Newcastle Inner City Bypass – Rankin Park to Jesmond

Project update

In response to community submissions during the exhibition of the environmental impact statement, a number of design changes have been made to the project. We have also made changes through the ongoing review of the concept design and consultation with other government agencies.

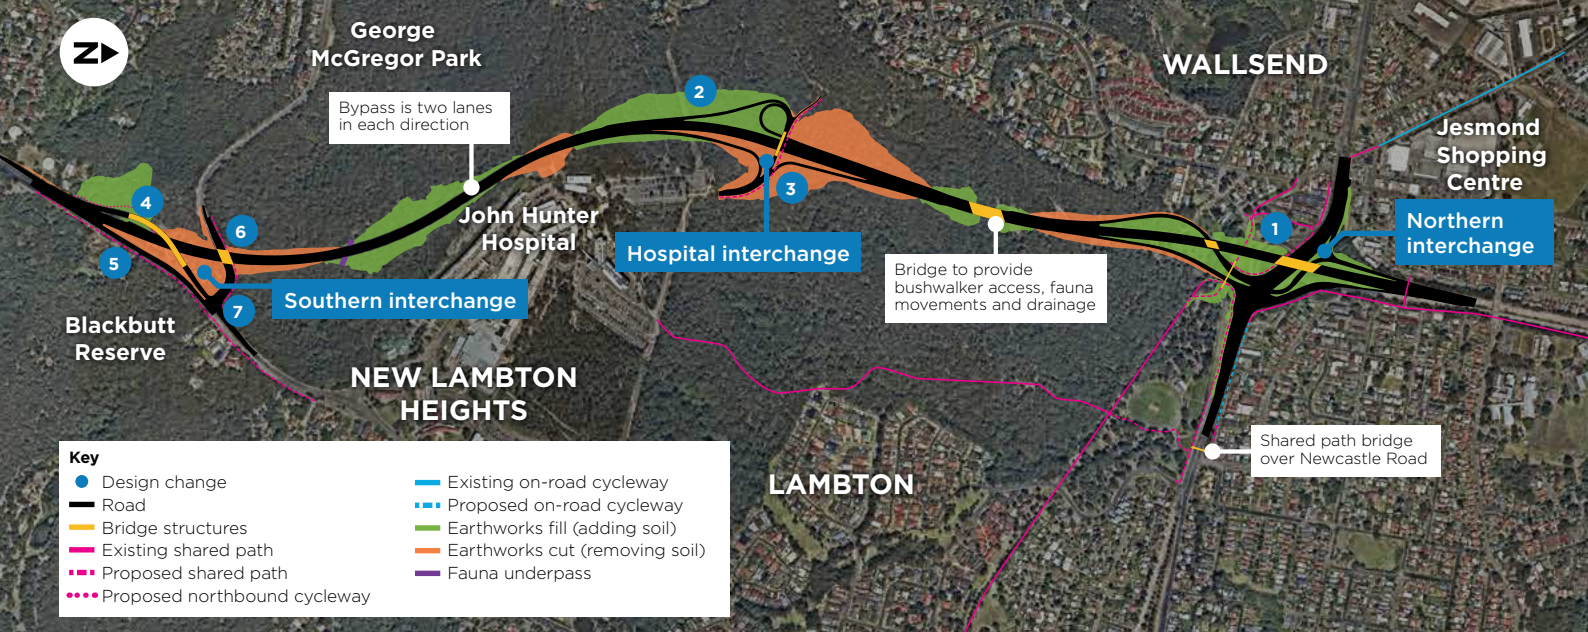
- 1 An east-west grade separated shared path would now be provided for the Jesmond Park cycleway to improve accessibility for pedestrians and cyclists. A shared path bridge would lead to an underpass of the bypass.

- 2 South facing ramps added to deliver a full interchange, providing access in all directions between the bypass and the hospital precinct for all hospital users including public, staff and emergency services.
- 3 Traffic lights added at the shared path crossing of the southbound off-ramp to improve safety for pedestrians and cyclists.

- 4 A northbound cycleway connection added from Lookout Road to the bypass to improve safety for on-road cyclists.
- 5 A southbound cycleway connection controlled by traffic lights added from the bypass to Lookout Road to improve safety for on-road cyclists.
- 6 The proposed pedestrian footpath on the northern side of McCaffrey Drive would now be replaced with a wider shared path for use by both pedestrians and cyclists.
- 7 The pedestrian crossings on the left turn from McCaffrey Drive onto Lookout Road, and across Lookout Road would now both be shared path crossings controlled by traffic lights.
